UNITED STATES PATENT AND TRADEMARK OFFICE

APPLICATION NO.	FILING DATE	FIRST NAMED INVENTOR	ATTORNEY DOCKET NO.	CONFIRMATION NO.
10/625,997	07/21/2003	Dale W. Petty	EH-10662R (02-391)	9899

Office Action Summary	Application No. 10/625,997	Applicant(s) PETTY ET AL.	
	Examiner William H. Rodriguez	Art Unit 3746

FIG. 7

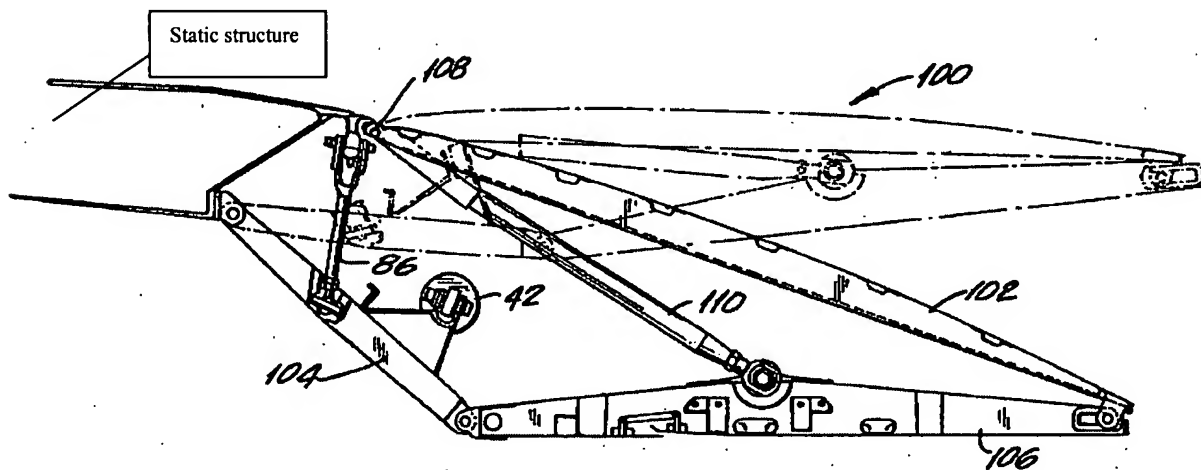
Nash teaches a turbine engine nozzle comprising: a static structure; a plurality of flap subassemblies arranged about an engine centerline comprising: an upstream flap 104; a downstream flap 106 pivotally coupled to the upstream flap for relative rotation about a hinge axis; an external flap 102 and an actuator linkage 110 couple to the downstream flap along a forward half thereof for actuating the upstream and downstream flaps so that the throat area is varied within a range of areas (min. and max. areas). See particularly cl. 5 ll. 28-30 and Figure 7.

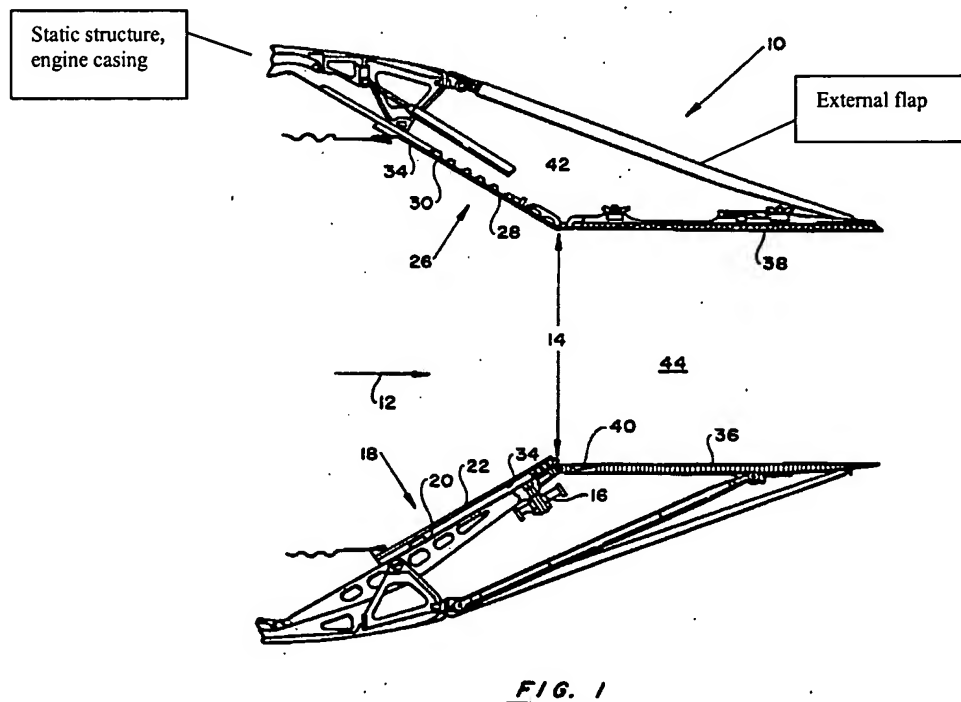
Tseng teaches a turbine engine nozzle comprising: a static structure 22; a plurality of flap subassemblies arranged about an engine centerline comprising: an upstream flap 32; a downstream flap 34 pivotally coupled to the upstream flap for relative rotation about a hinge axis; an external flap 33 and an actuator linkage 36 couple to the downstream flap along a forward half thereof for actuating the upstream and downstream flaps so that the throat area is varied within a range of areas (min. and max. areas). See particularly cl. 3 ll. 64-67 and Figure 2.
